**Re: Texas Custodial Trust
Former ASARCO Smelter Site, El Paso, Texas**

Subject: Cell 4 Final Cover Design

**Subject: Response to EPA Comments on Category I Landfill, Cell 4 Final Cover Design
Texas Custodial Trust
Former ASARCO Smelter Site, El Paso, Texas**

<p>HYDRAULIC GRADE LINE ALONG DOWNCHUTE FOR PBA INTERIM CONFIGURATION</p>	
<p>Geosyntec[®] consultants TEXAS ENGINEERING FIRM REGISTRATION NUMBER 1182</p>	
<p>NOT TO SCALE</p>	<p>JUNE 2014</p>
<p>Figure: 1A</p>

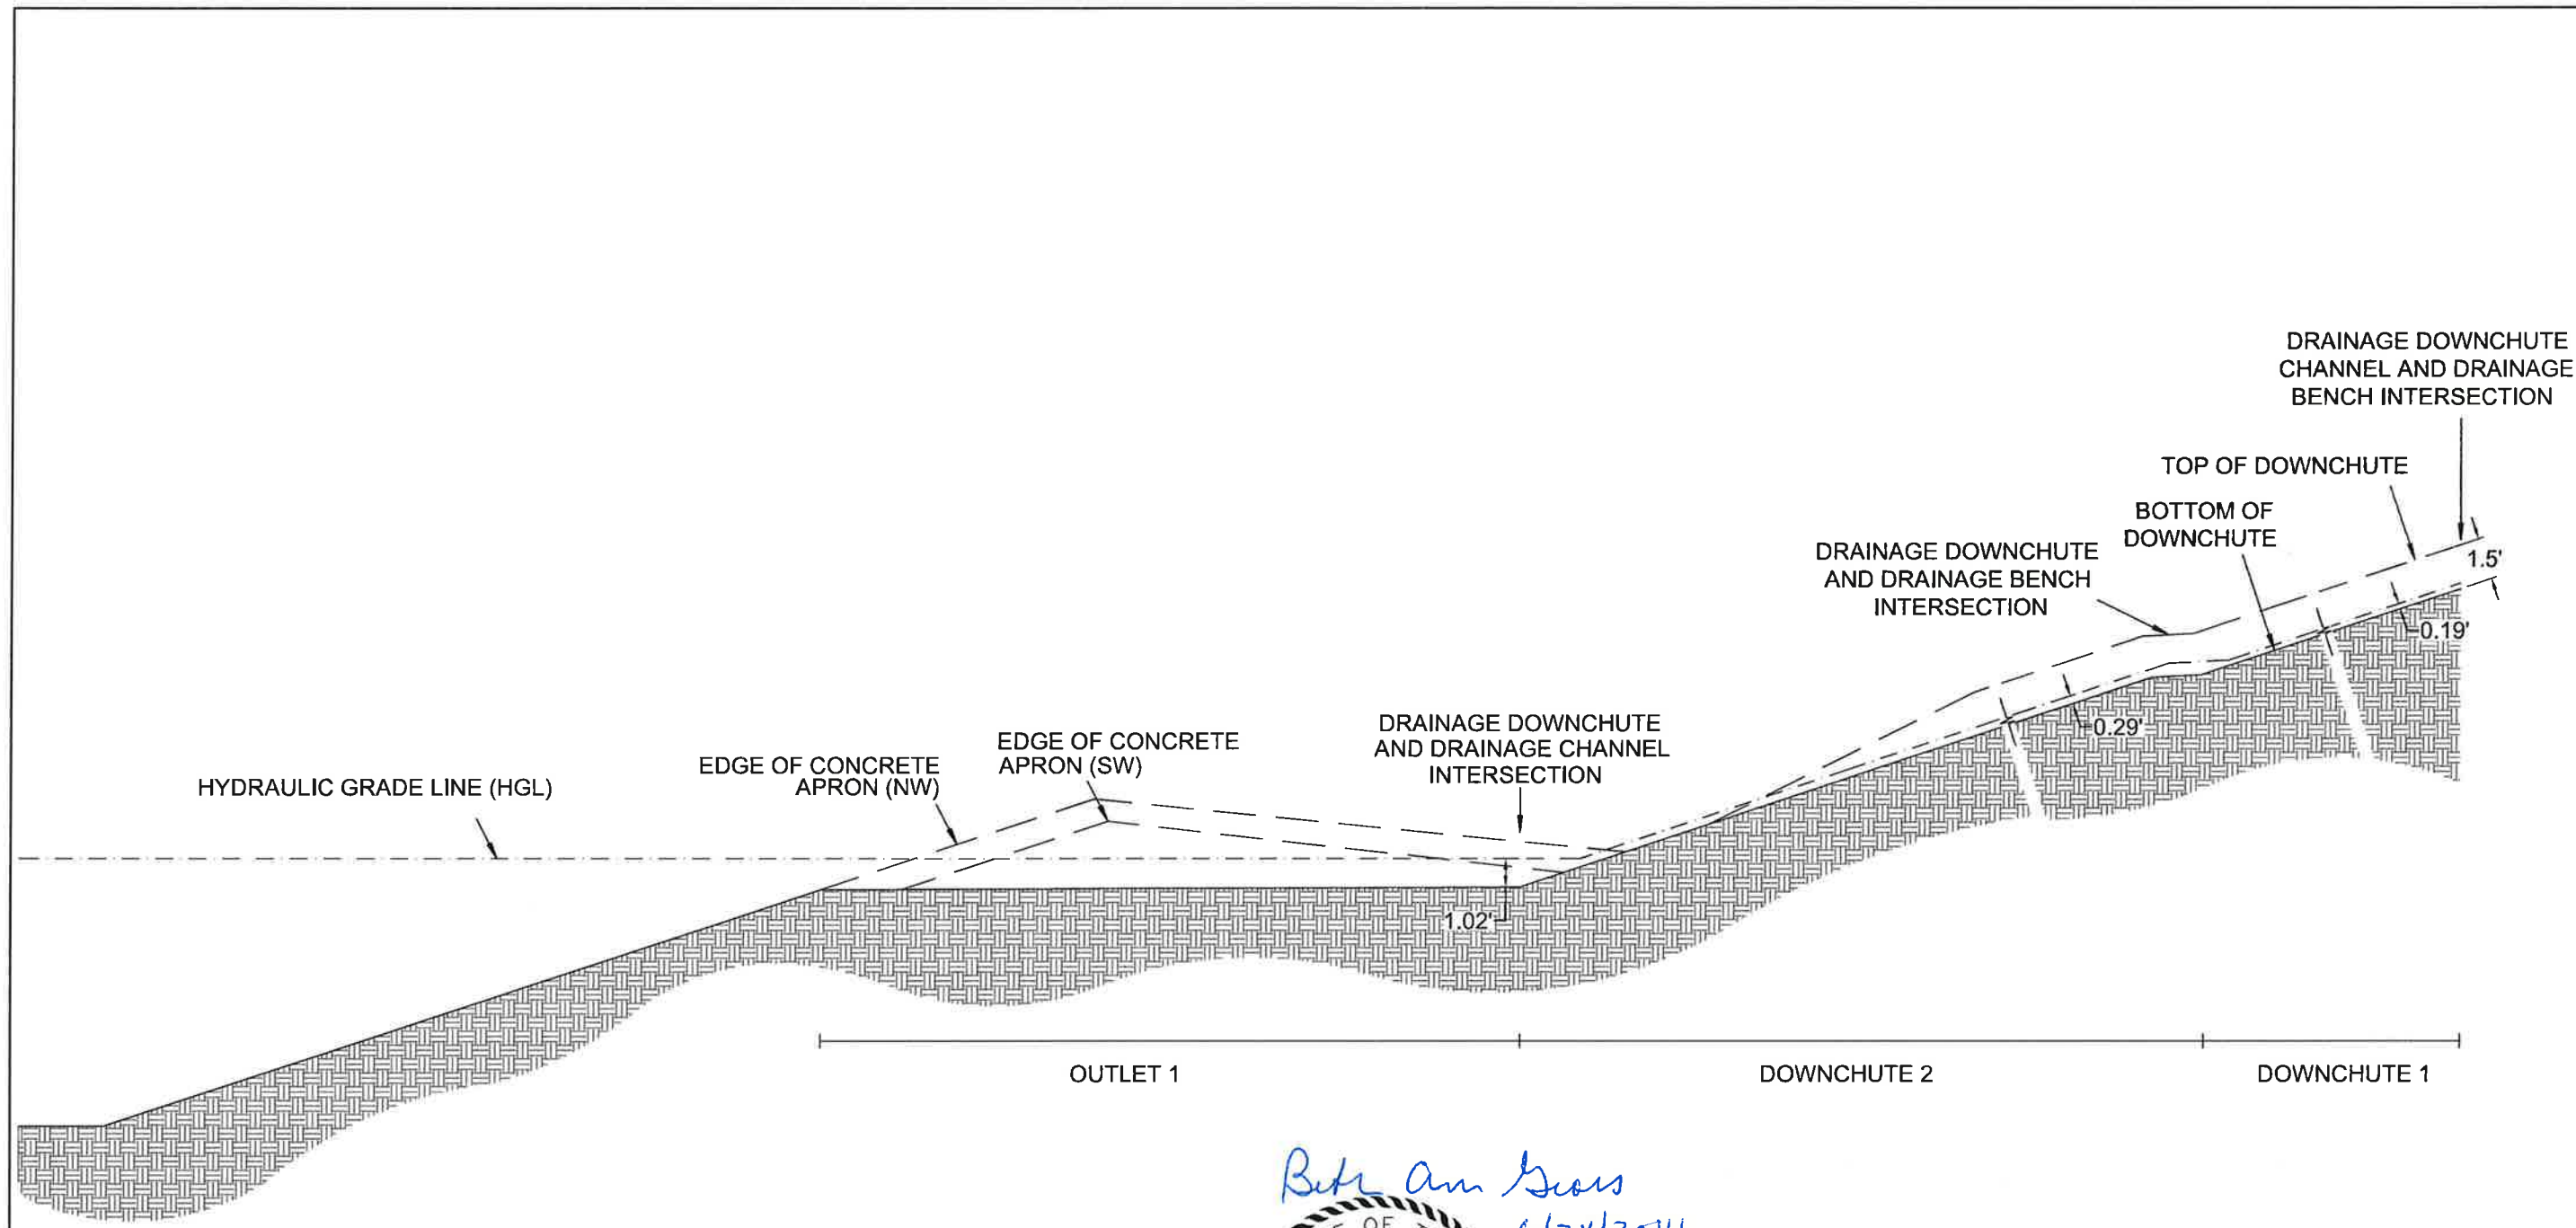
(C) Provide Calculations of the Landfill storm-water flow velocity and the discharge rate (Q, cfs) of storm water flowing down the chute Channel. Provide the hydraulic grade line of the 100 year frequency return storm.

(G) Show calculations of the Chute Channel design and the discharge flow rate in the chute channel. Draw and label the hydraulic grade line in the chute profile.

The calculated velocities and flow rates for each reach of the downchute are provided in Attachment C. The hydraulic grade line along the downchute for the 100-yr, 24-hr storm event is shown in Figures 1a and 1b. Figure 1a includes the hydraulic grade line in Parker Brothers Arroyo (PBA) for the Interim Configuration, which includes an overflow weir (see Sheet 4 of 9 in Attachment F). This is the current condition of PBA at the site. Figure 1b shows the hydraulic grade line in PBA for the final configuration after the overflow weir has been removed. It is anticipated that the weir will be removed in 2015.

The calculated velocities and flow rates for each reach of the downchute are provided in Attachment C. The hydraulic grade line along the downchute for the 100-year, 24-hour storm event is shown in Figures 1a and 1b.
